# ADDENDUM NO. 01

**Project Name:** TFSD Morningside HVAC Replacement

**Date Issued:** February 5, 2025

**ROOF TIE ANCHOR SUPPORT DETAIL**

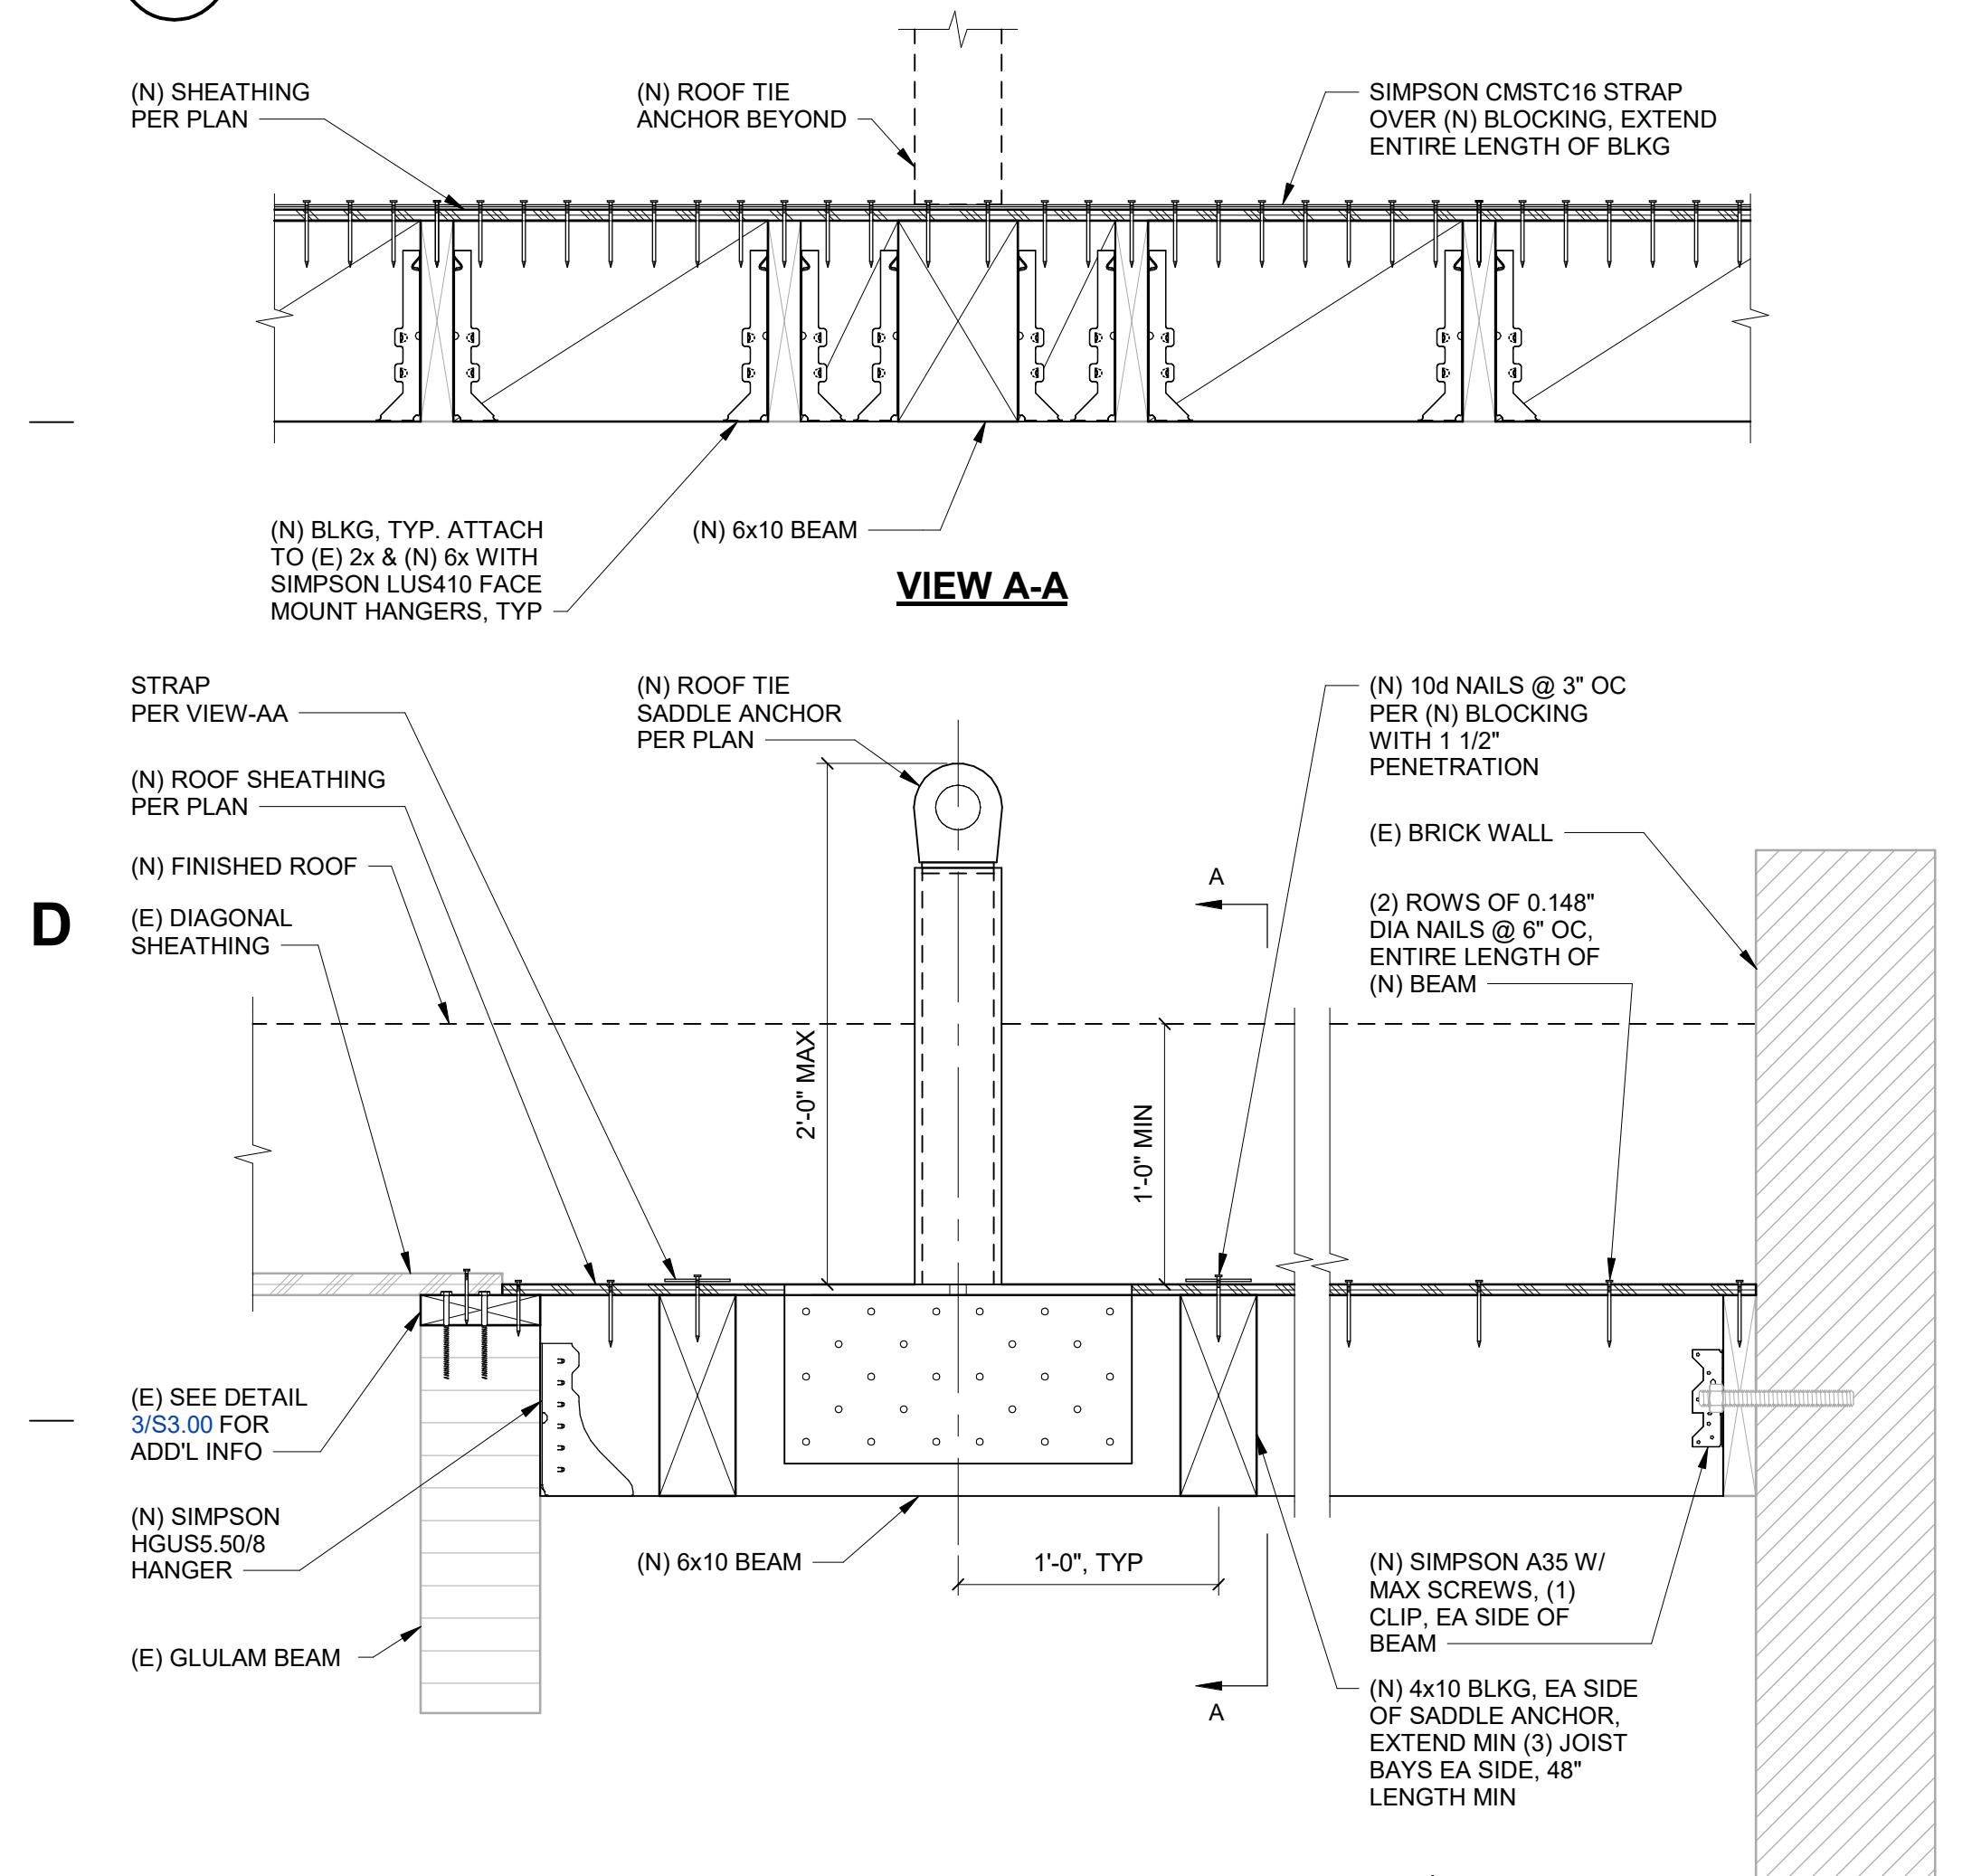
1. Roof tie anchor support detail, 8/S3.02 was added.

Sheet No: M3.11

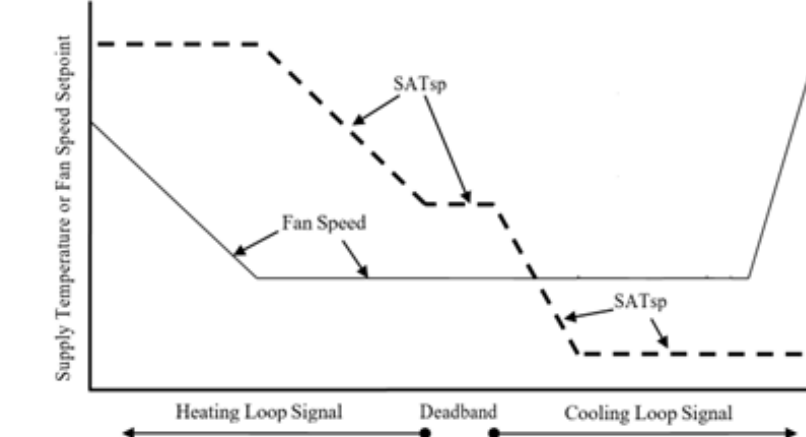
1. Added factory packaged refrigerant monitor and safeties per code.

- Refrigerant Leak Detection (Factory Controls)
    - Upon leak detection by the refrigerant sensor the supply fan shall be enabled (if not already enabled) and run until refrigerant is diluted below permissible levels.

- The factory control panel shall display that a leak has occurred and be visible until alarm is acknowledged.
